Access Compliance Report

Public Rights-of-Way

(Curb Ramps)

Intersection ID: 30294	Main Street: ELSBERRY_LN	Cross Street: RAVANNA_DR	Location: W
ADA ID: F3EF21AB04AD	Ramp Type: PerpDiag	Initial Pass/Fail: Fail	Overall Compliance: No
Severity Score: 47.5			
Codes/Mitigation Info/Possible Solution		Field Measurements/Component Compliance

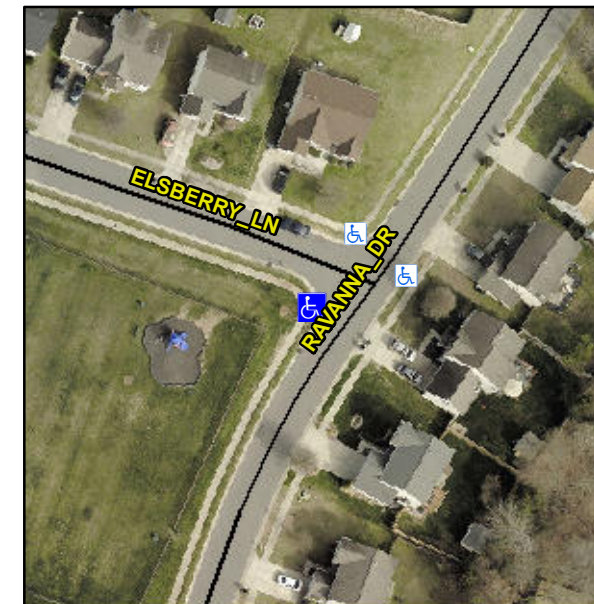
Not Found, R304.5.1, R304.5.3

Compliance	Description	Data	Compliance	Description	Data
N/A	Ramp Length (in)	48.5	Yes	Ramp Slope (%)	5.0
No	Ramp Width (in)	31.0	No	Ramp XSlope (%)	6.3
N/A	Flare Type LT	N/A	N/A	Flare Type RT	N/A
N/A	Flare Slope LT (%)	N/A	N/A	Flare Slope RT (%)	N/A
N/A	Flare Traversable LT?	N/A	N/A	Flare Traversable RT?	N/A
N/A	Landing Length (in)	N/A	N/A	DWS Provided?	N/A
N/A	Landing Width (in)	N/A	N/A	DWS Contrast?	N/A
N/A	Landing Slope (%)	N/A	N/A	DWS Length (in)	N/A
N/A	Landing X Slope (%)	N/A	N/A	DWS Full Width?	N/A
N/A	Landing Curb? (Y/N)	N/A	N/A	DWS Offset (in)	N/A
N/A	Shared Landing?	N/A			
N/A	Gutter Ponding?	N/A	N/A	Gutter Slope (%)	N/A
N/A	Gutter Lip Ht (in)	N/A	N/A	Gutter X Slope (%)	N/A
N/A	Painted X Walk1?	No	N/A	Painted X Walk2?	No
	X Walk 1 Direction	To S		X Walk 2 Direction	To N
N/A	X Walk 1 Width (in)	N/A	N/A	X Walk 2 Width (in)	N/A
	X Walk 1 Slope (%)	0.8		X Walk 2 Slope (%)	6.6
	X Walk 1 X Slope (%)	5.6		X Walk 2 X Slope (%)	0.1

Remove & Replace Curb Ramp With Two New Directional Ramps or Equivalent.
